Hints & Kinks

DB6NT's 24 GHz-Transverter

Hints for construction (Aufbauhinweise):

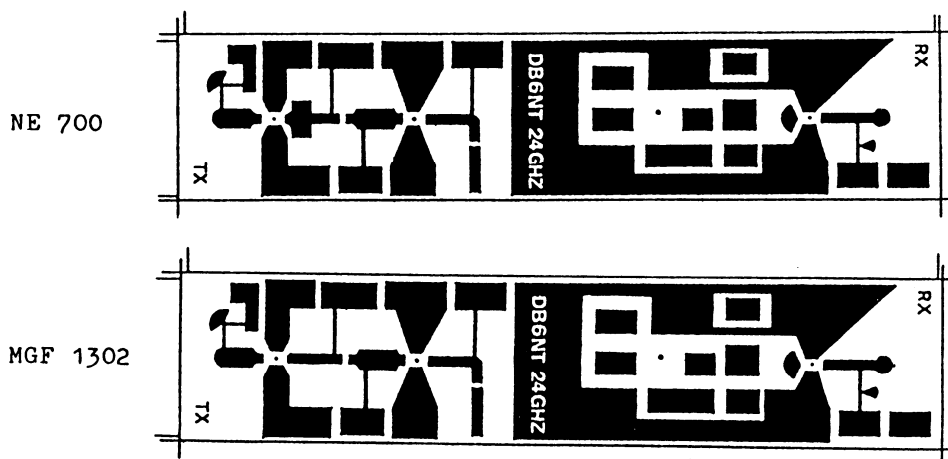
1. New PCB for change of T4 from NE700 into MGF-1302:

2. Change of 150 k resistor in IF-Amp into 100k or 82 k:
